SITE PLAN FOR JOHN CHESNIC
 BEING A PART OF LOT NO. 31 IN THE TOWNSHIP OF LEROY, COUNTY OF LAKE, STATE OF OHIO.

HYDRAULIC PROFILE
 VERT. 1" = 3' HORZ. 1" = 30'
 3 BEDROOM RESIDENCE

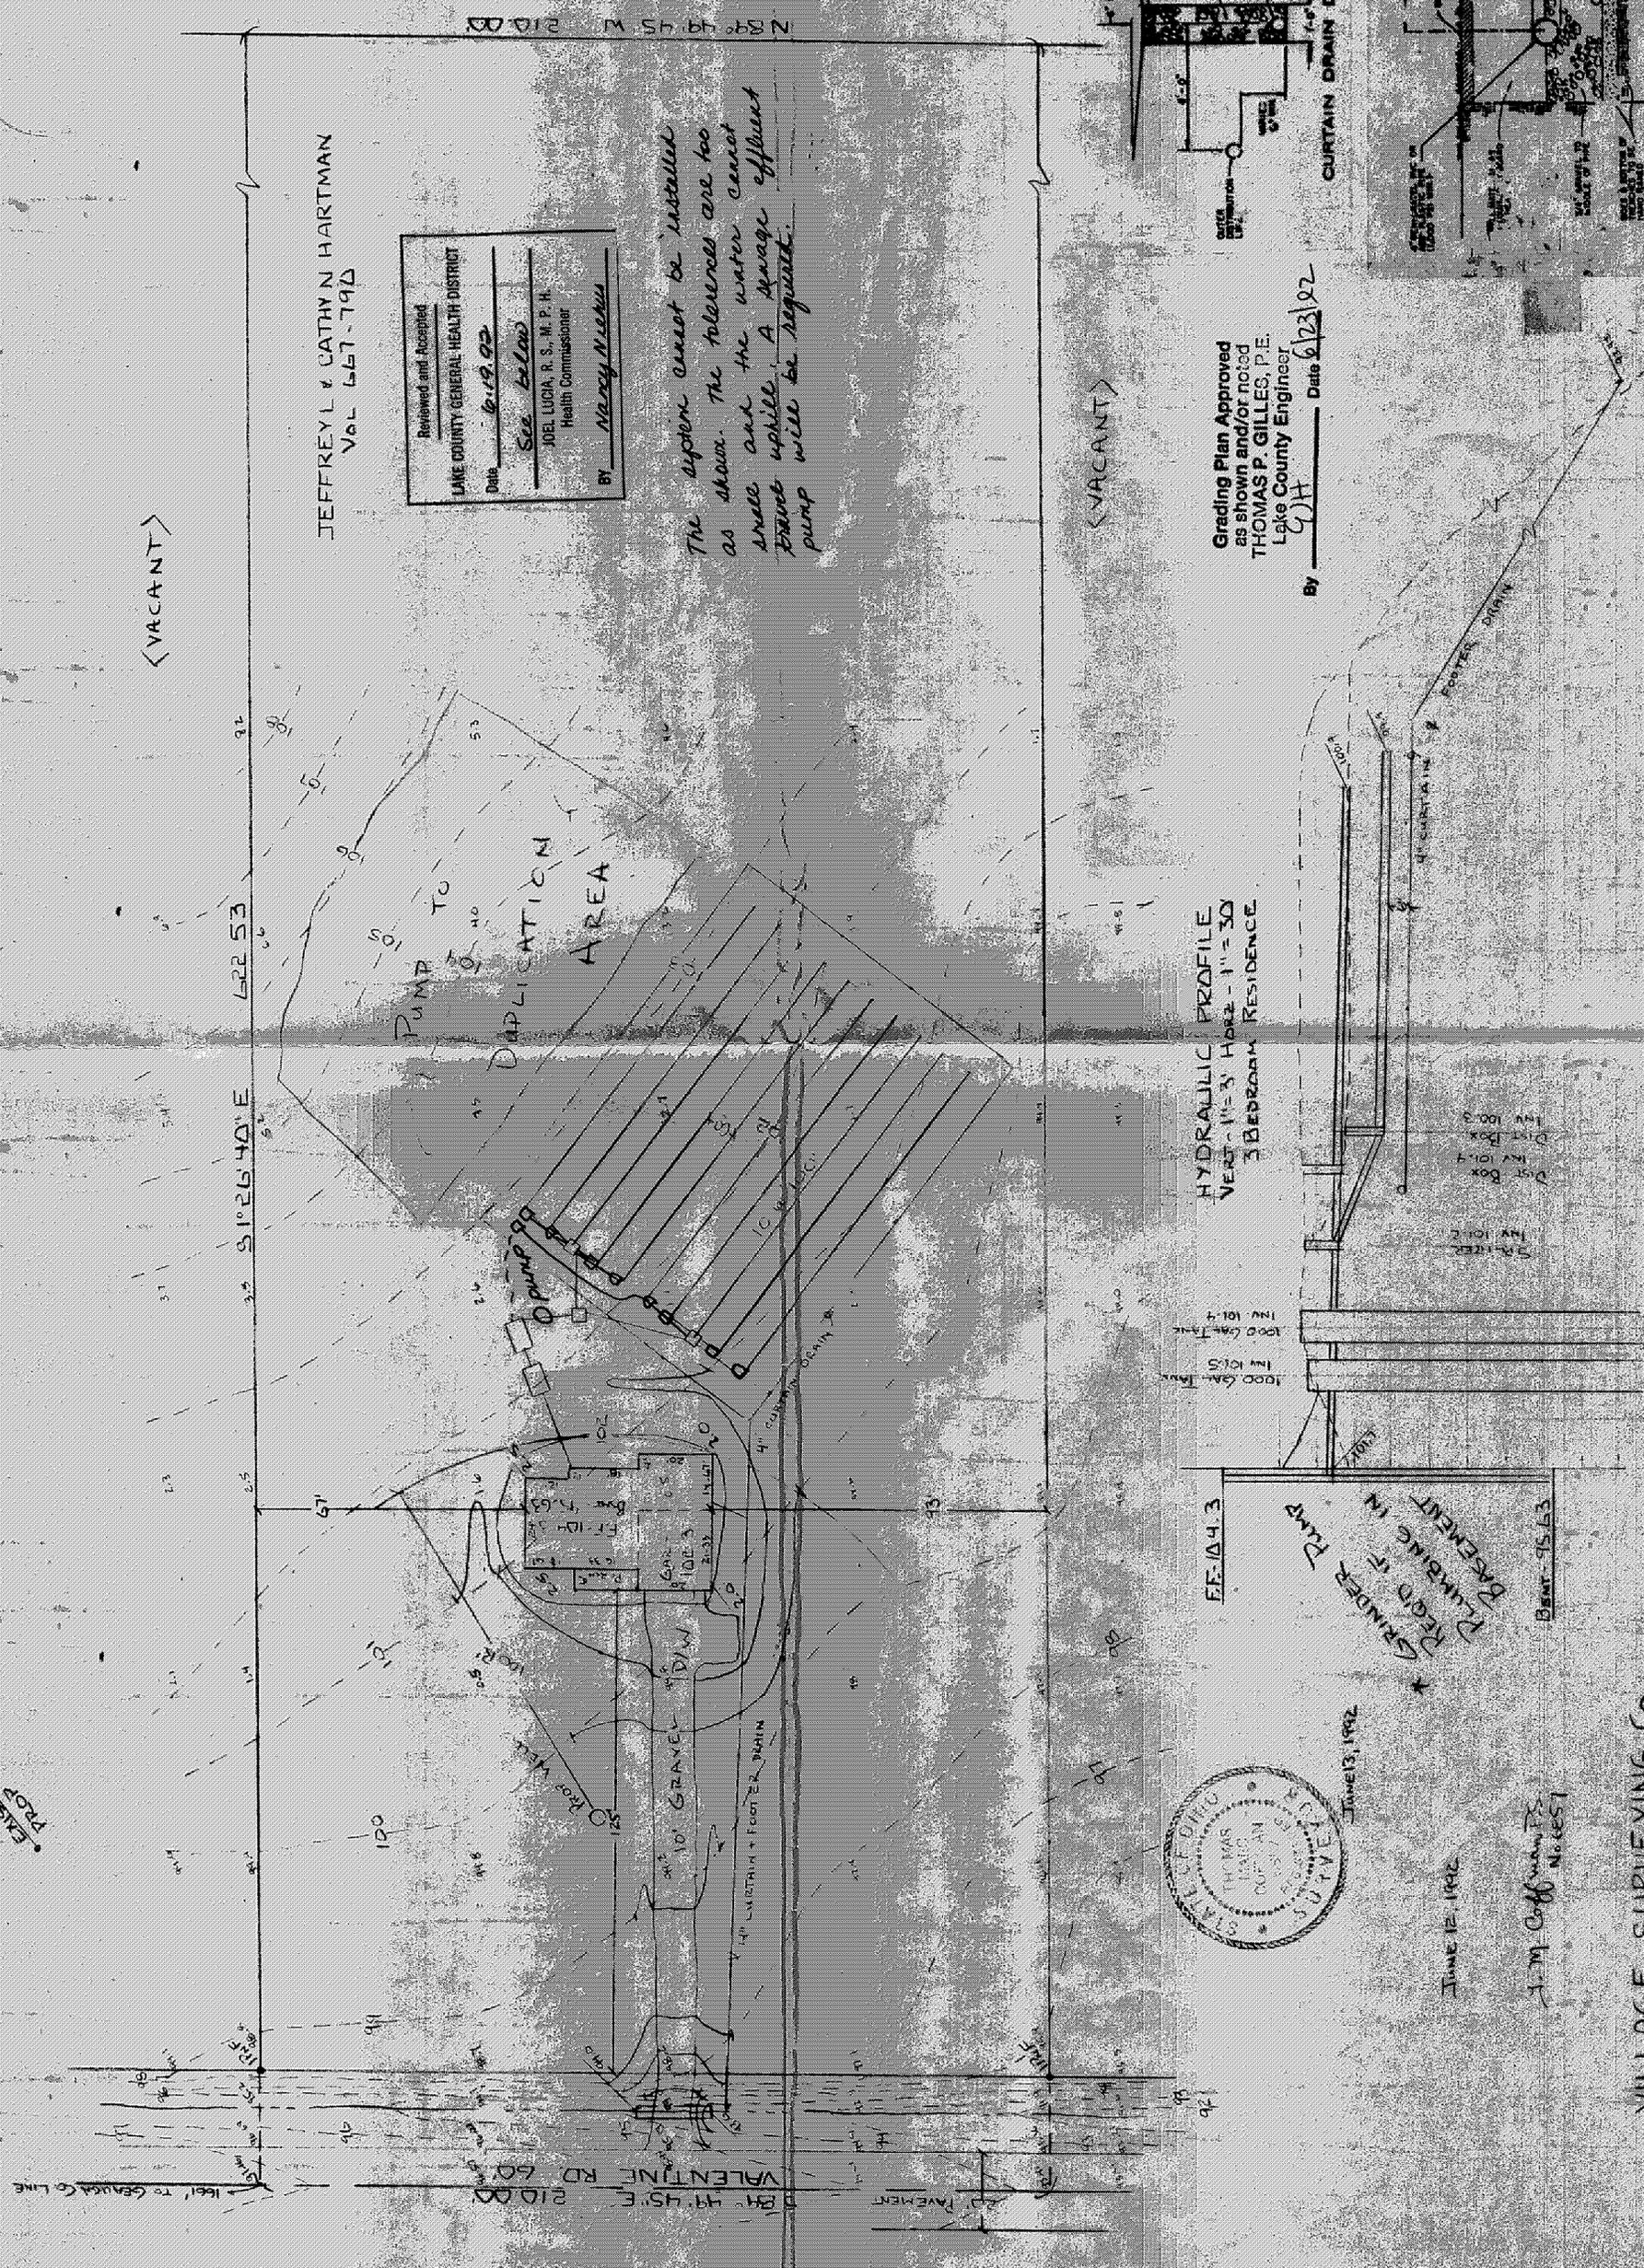
The system cannot be installed as shown. The tolerances are too small and the water cannot travel uphill. A sewage effluent pump will be required.
